MRP-SEIS-105
P. 1074

REF: Scoping Comments for Merced River Plan (MRP)

REF: Draft Merced Wild and Scenic River Management Plan

PROPOSED CHANGE NO. 1

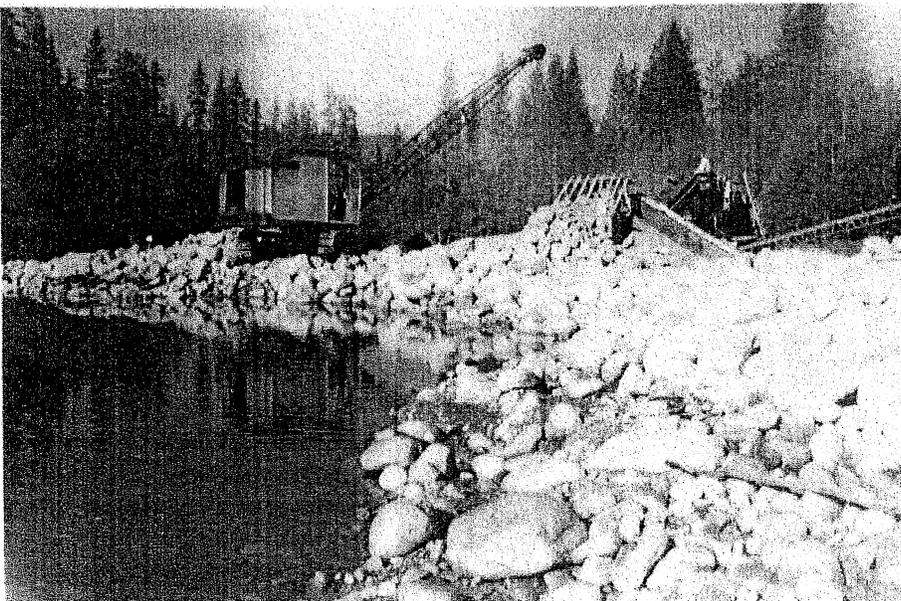
The first change I proposed was to simply remove the proposed zoning from within Section 35. The Wawona Specific Plan is the mechanism that should be used to manage that portion of the river corridor. In Alternative no. 2, that would mean removing the proposed 2B Discovery zone and incorporate appropriate language in the present Flood Plain zone. As I stated, the Land Use Subcommittee of the Wawona Town Plan Advisory Committee has already recommended such a change. Whereas, applying new zoning on top of existing zoning would lead to inevitable conflicts, utilizing the existing zoning document would eliminate conflicts and insure that the language would apply to private as well as public property.

You said, "That's a good idea", and directed Kevin Cann to inform Amy Scheneckenburger.
